Intel[®] StrongARM^{*} SA-1111 Microprocessor Companion Chip

Specification Update

May 2002

Order Number: 278260-013

Figure 2-2. SA-1111 Reset Sequence

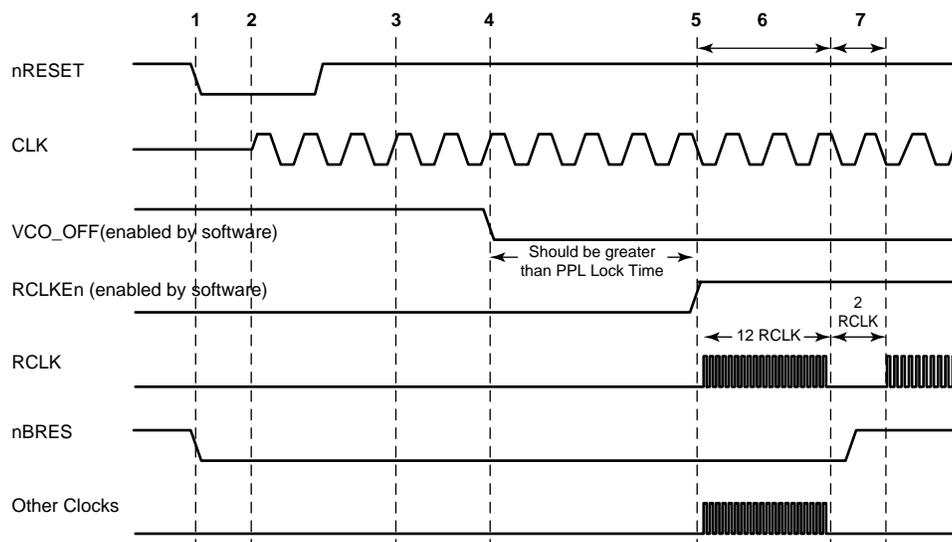
2. System Reset, Section 2.3

Changed VCO_On to VCO_Off in Step 4 of the procedure and clarified the step. Step 4 now appears as follows:

Changed VCO_On to VCO_Off and the signal in Figure 2-2. Figure 2-2 now appears as follows:

4. VCO_Off is deasserted by software (SKCR Bit <4> =0) and PLL_Bypass is deasserted by software (SKCR Bit <0>=1)

Figure 7-4. MSB-Justified Data Formats (16 bits):

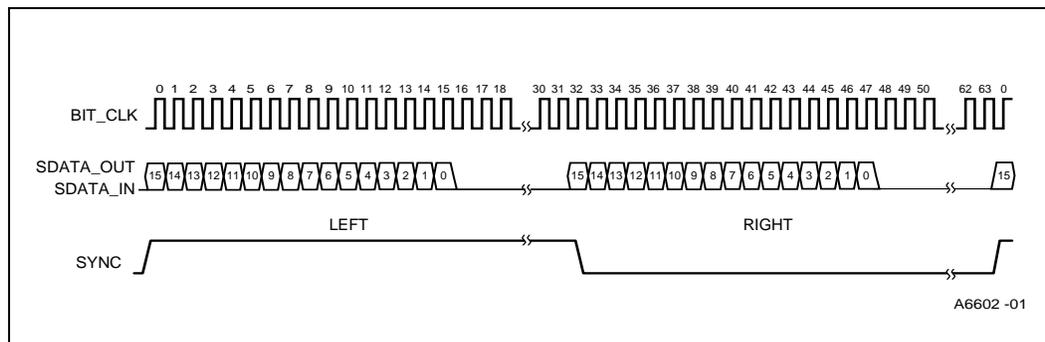
5. I²S and MSB-Justified Serial Audio Formats: Section 7.3.2.2

Update Figure 7-4 MSB-Justified Data Formats (16-bits). Figure 7-4 now appears as follows:
